Differential Return Loss for Clause 137 and Matched COM Package Parameters

For Comments #92 and #93

Richard Mellitz, Samtec

March 2017 IEEE802.3 Plenary, Vancouver, BC, Canada

OPTION B: Do nothing and keep what is in D1.2

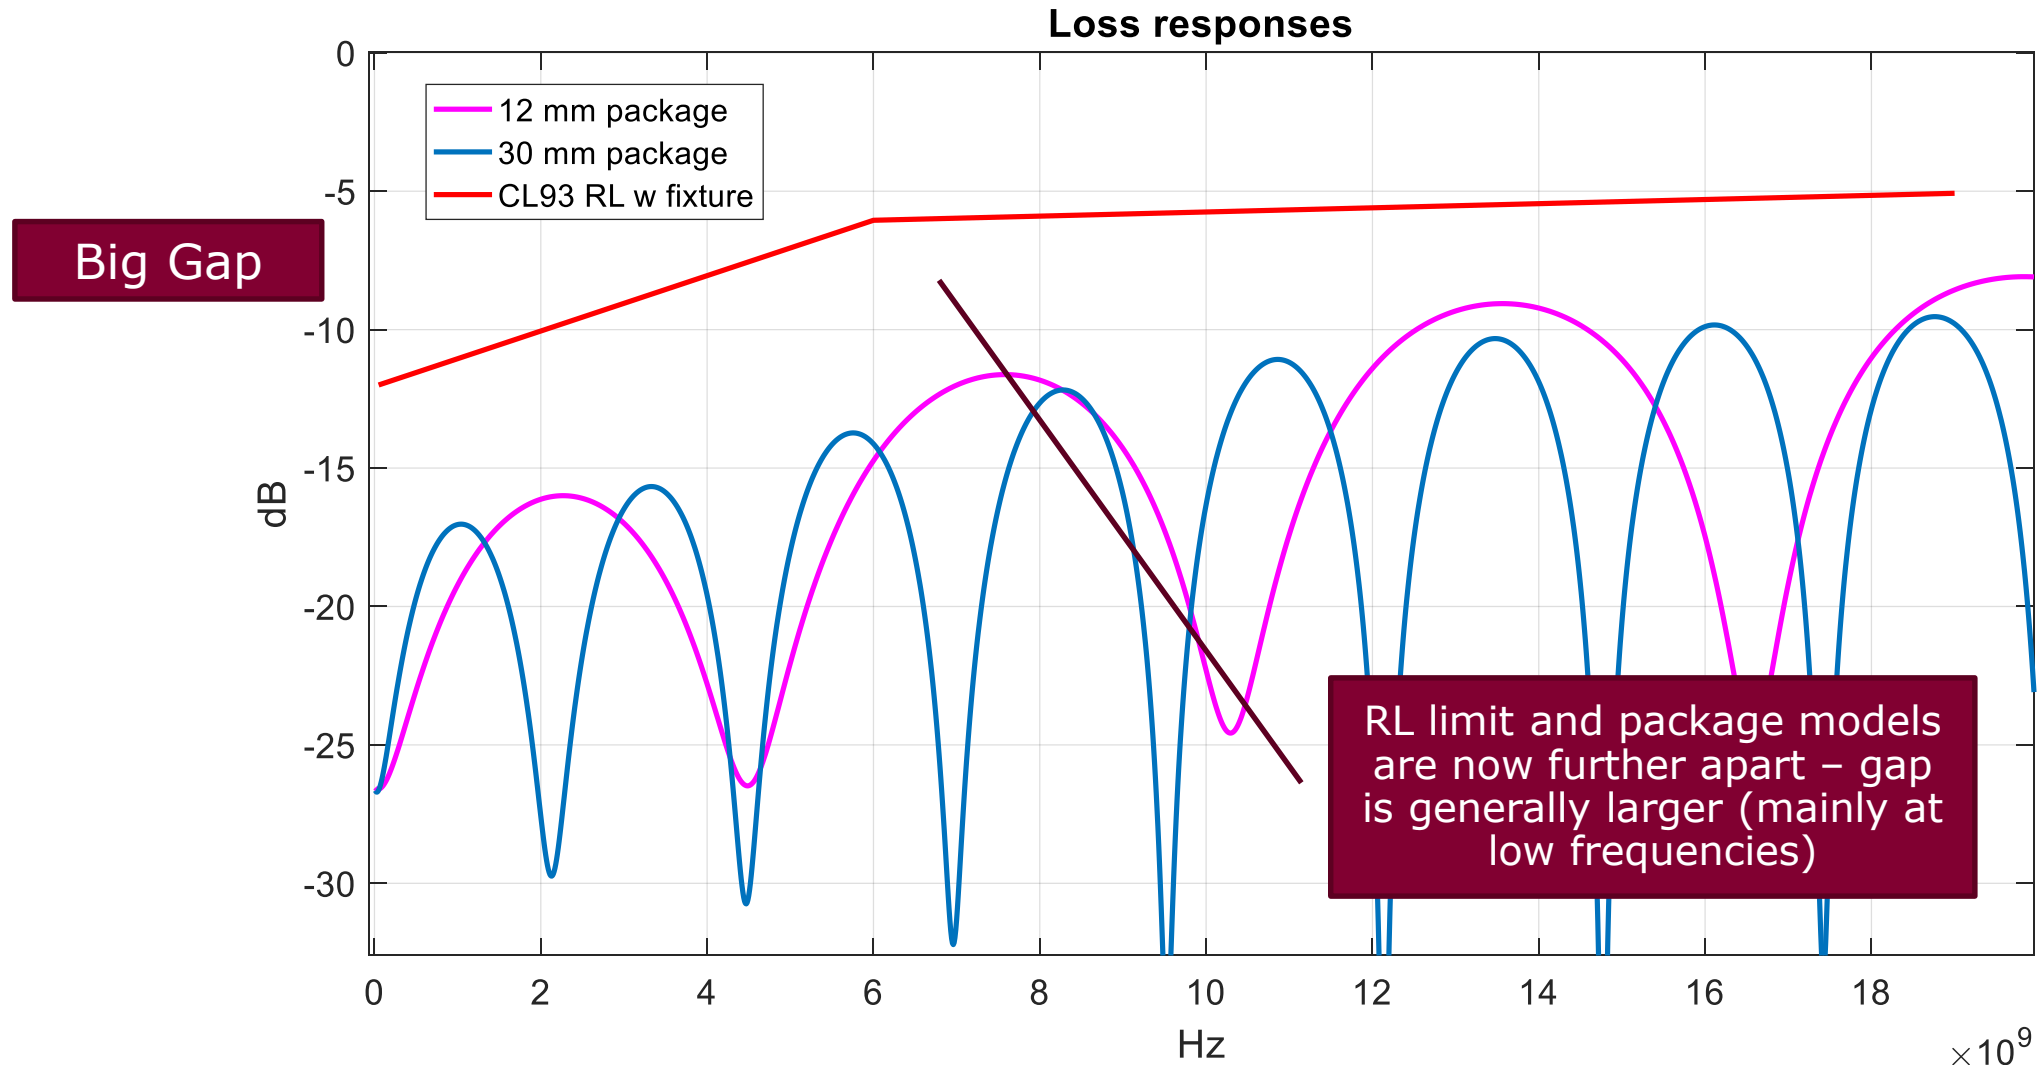
COM package return loss compared to RL limit

OPTION C D3.0 packages and lower RL to match package COM package return loss compared to RL limit

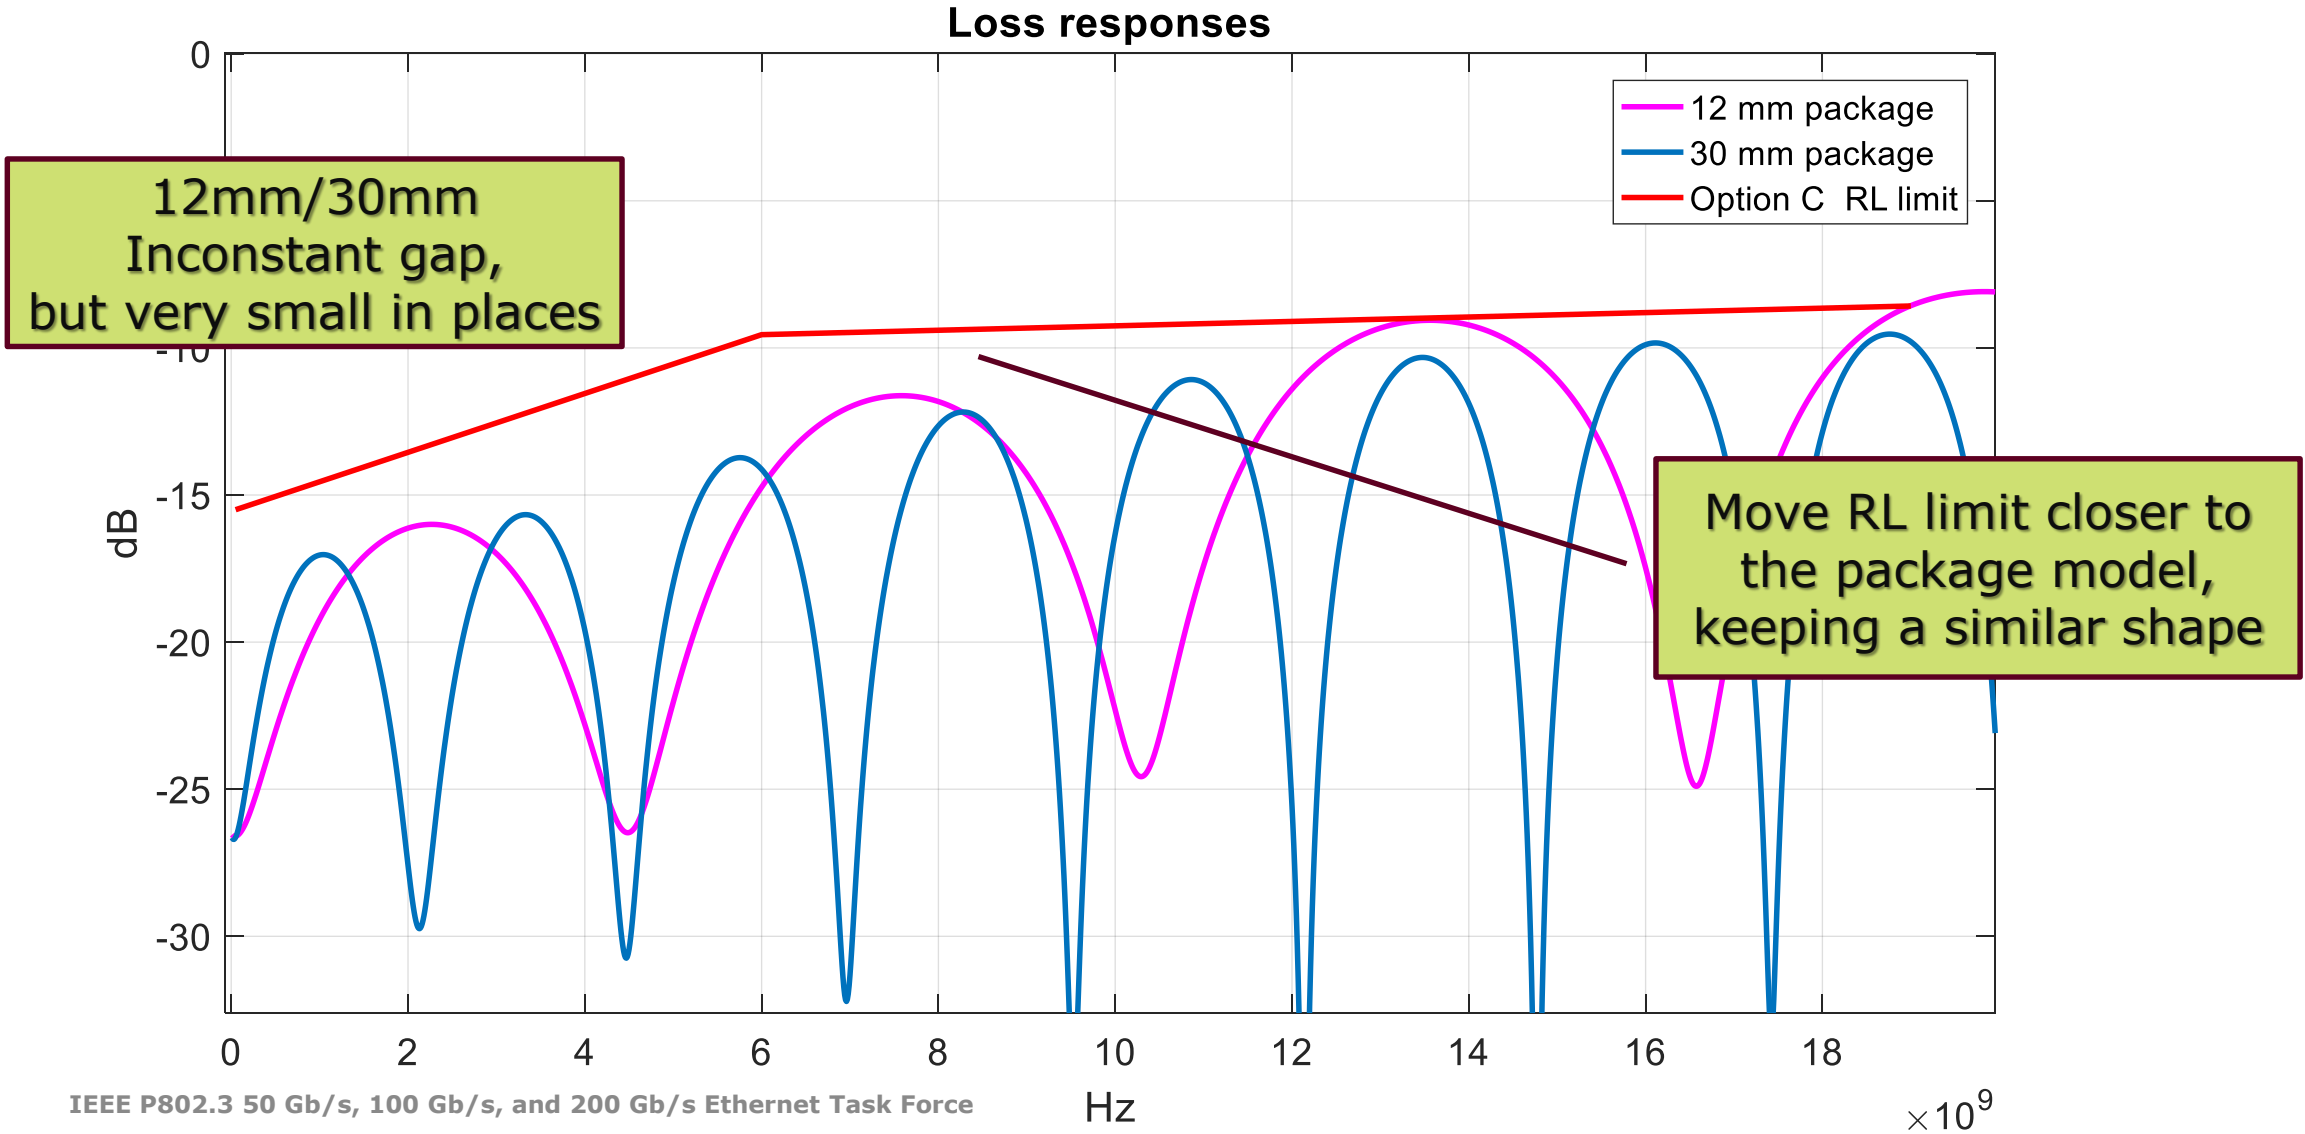
OPTION C: keep packages in D3.0 and lower return loss by 3.5 dB to match package

$$RL_d(f) \geq \left\{ \begin{array}{ll} \overset{15.55}{\cancel{12.05}} - f & 0.05 \leq f \leq 6 \\ \overset{10}{\cancel{6.5}} - 0.075f & 6 < f \leq 19 \end{array} \right\} \text{ dB}$$

Option D: Pedantic COM package for Option C Return Loss

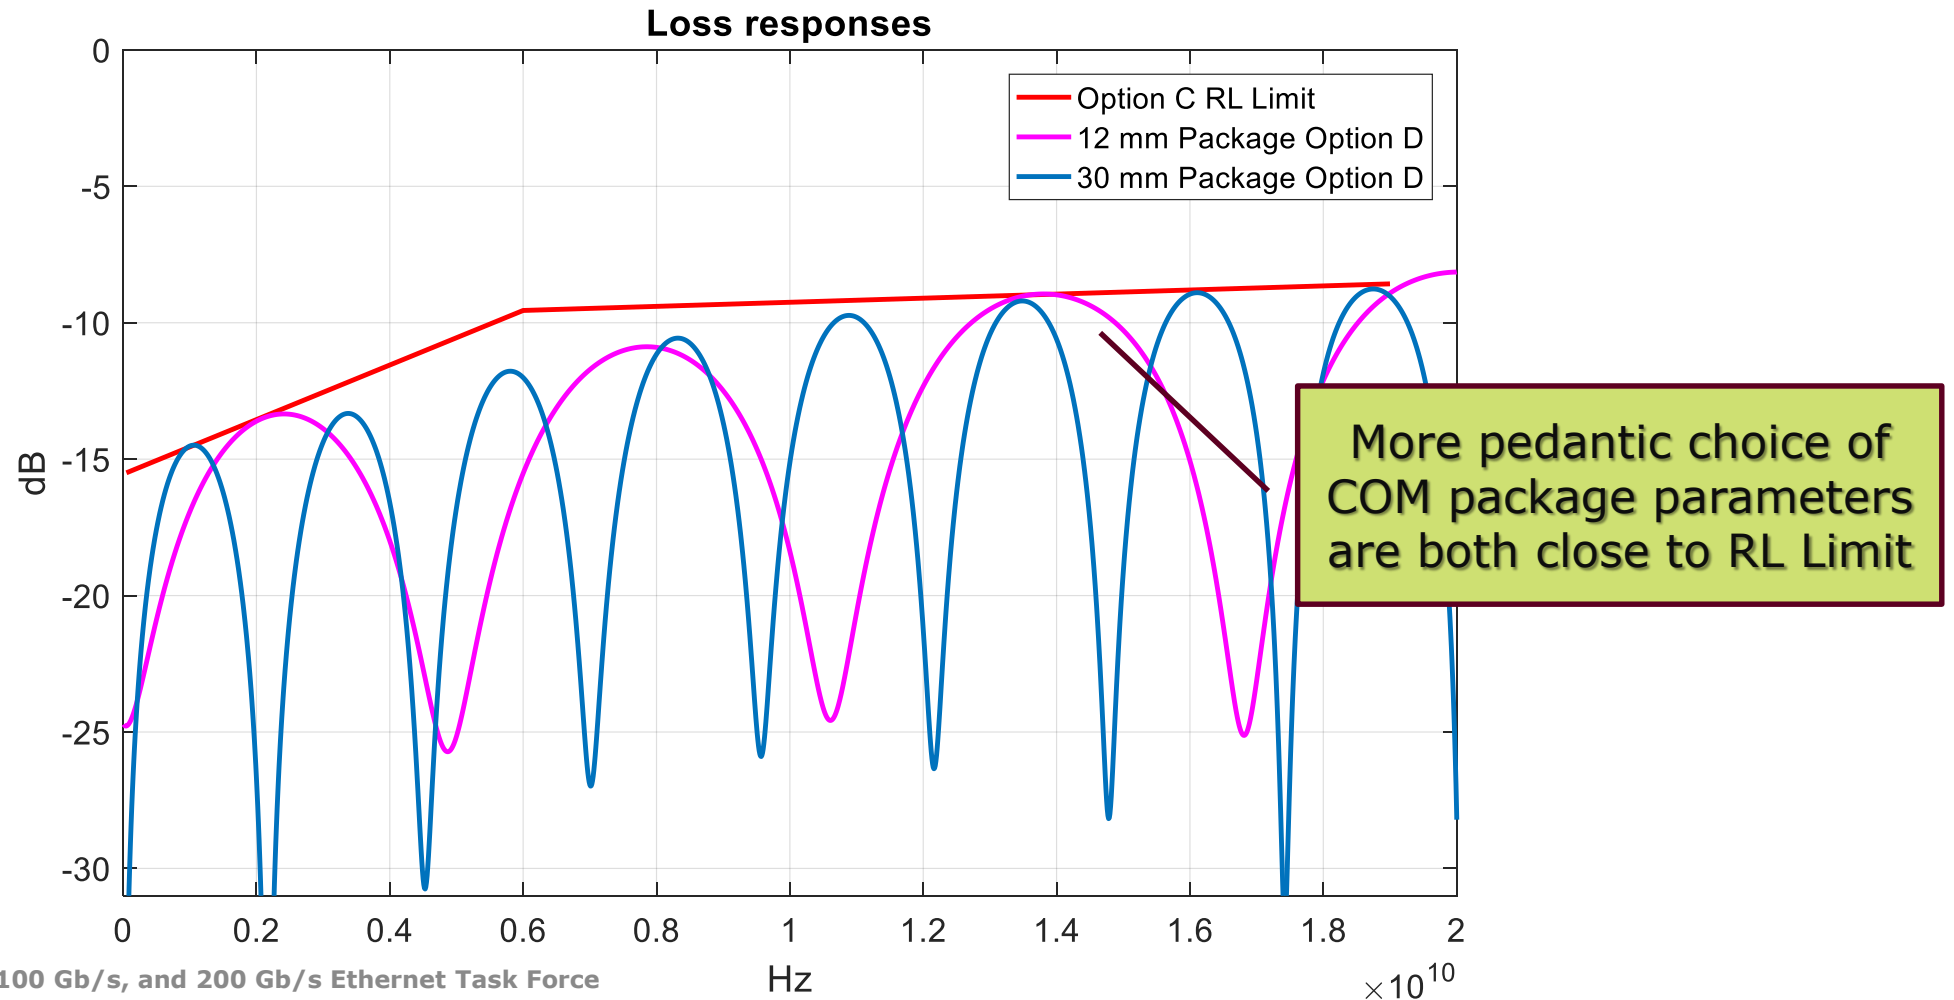
COM package return loss compared to RL limit

Device package model			
Single-ended device capacitance Test 1	Cd	1.78×10^{-4}	nF
Single-ended device capacitance Test 2	Cd	2.7×10^{-4}	nF
Transmission line length, Test 1	Zp	12	mm
Transmission line length, Test 2	Zp	30	mm
Single-ended package capacitance at package-to-board interface	Cp	1.1×10^{-4}	nF
Package transmission line characteristic impedance Test 1	Zc	84.5	Ω
Package transmission line characteristic impedance Test 2	Zc	82	Ω

Single-ended termination resistance Test 1	Rd	45	Ω
Single-ended termination resistance Test 2	Rd	50.5	Ω
